FSN Ref: 2024-FSN-00019

Date: 2024-07-31

URGENT Field Safety Notice
Risk of optical sensor damage in Impella products when used
concurrently and in close proximity with Shockwave Coronary IVL
Catheter

Example of a “Placement Signal Not Reliable” alarm that may occur:

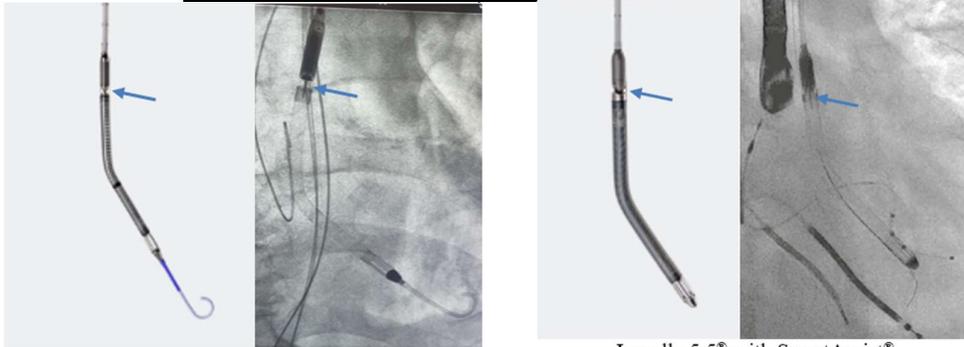
2. Reason for Field Safety Corrective Action (FSCA)*	
2.	<p>1. Description of the product problem*</p> <p>Abiomed has determined that there is a risk of optical sensor damage in Impella products as listed above when used concurrently and in close proximity with Shockwave Coronary IVL Catheter which is in active distribution within your country or territory. Placement Signal Not Reliable alarm may occur and subsequently disable pump position monitoring. Loss of the placement signal does not impact Impella hemodynamic support.</p>

Abiomed recommends the user to maintain adequate distance (> 20 mm) between the IVL device and Impella optical sensor and include optimal positioning of the Impella catheter with the radiopaque marker band located at the aortic valve annulus.

If optical sensor failure occurs, monitor patient hemodynamics and confirm Impella positioning with imaging. The pump will still operate but placement and suction monitoring will be suspended.
